Parker Hannifin Corporation

PRODUCT REFERENCE MEMO

40-78, 40-78A, 40-78B, 40-78E, AND 40-78J WHEEL ASSEMBLIES, TIE BOLT / OVERHAUL SET AVAILABILITY

Figure 1 New Configuration

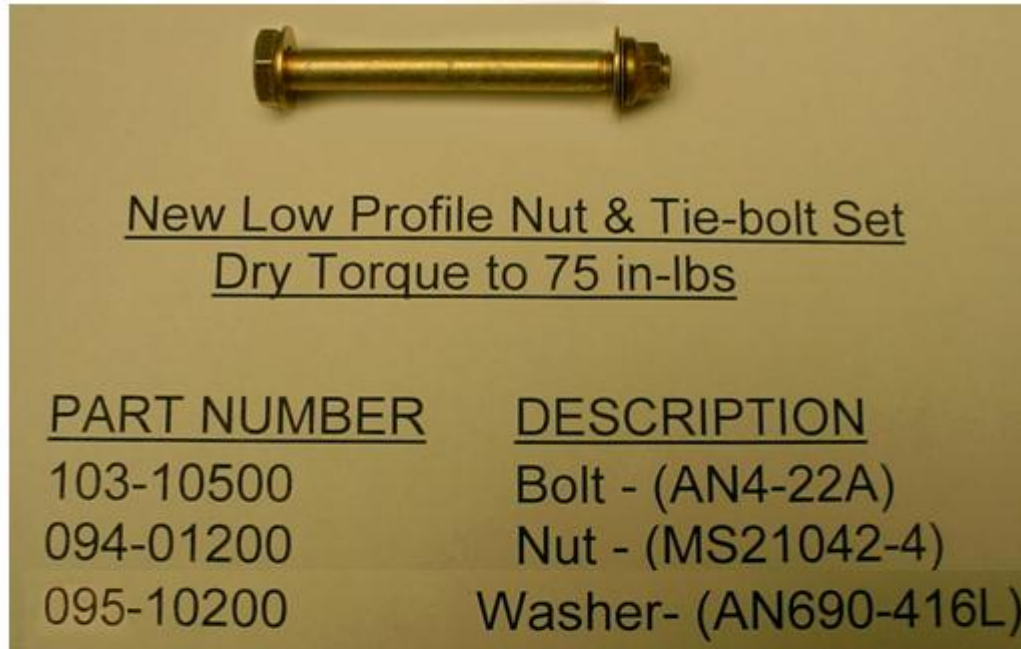
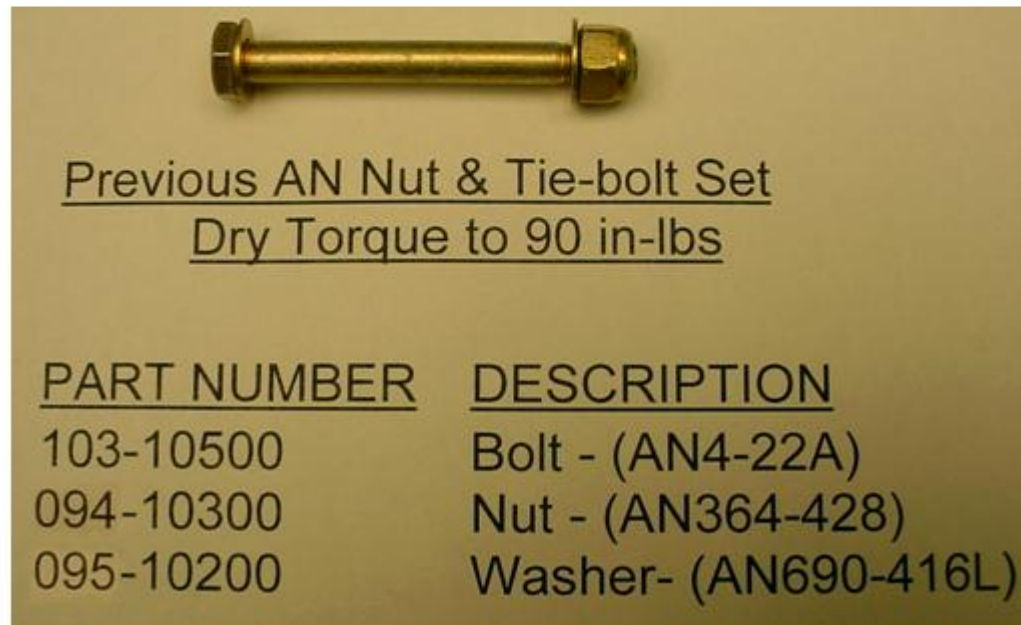
To bring these wheels into compliance with Cleveland's current fastener design standard and inform Owner/Operators of the resulting new washer thickness and low profile nut for the subject wheel assemblies.

The original tie bolt system guidance from the 1972 standard, AC43.13.1A, Chapter 5, Section 1, Para 230 (a) (2), permits just the chamfer or round end of the bolt to be seen at the top of the nut. No failure has occurred as a result of this original tie bolt system.

Cleveland's current fastener design standard, AC43.13-1B, Chapter 7, Section 4, Para. 7-64 (f) recommends a minimum of one thread exposure above the nut.

Thus we are updating these assemblies with low profile all metal lock nuts that meet the minimum of one thread exposure above the nut under all conditions. The low profile nut provides distinct visual indication of proper thread engagement. Use of the existing nut is still an accepted configuration; however, a different torque value is required. Refer to Figures 1 and 2 for configuration examples.

- (1) At next tire change or overhaul replace the tie bolt set and incorporate the low profile nut per this Product Reference Memo.
- (2) At next available maintenance interval, and at Owner's discretion, inspect tie bolt system for evidence of one complete thread exposed from the nut. If one complete bolt thread is exposed above the nut, aircraft may be returned to service at Owner's discretion.

- (8) Reassemble wheel per maintenance manual instructions installing one (1) washer under each nut and DRY torque the nuts in two steps; first to 35 lb-in (3,95 N-m) then to 75 lb-in (8,5 N-m). ALWAYS restrain the bolt head and torque the nuts using a crisscross pattern until all nuts are properly torqued. Lubricant is **NOT** to be used.
- (9) Place warning label adjacent to valve hole.
- (10) Place identification label opposite valve hole.
- (11) Reinstall wheel on aircraft per applicable aircraft manual.
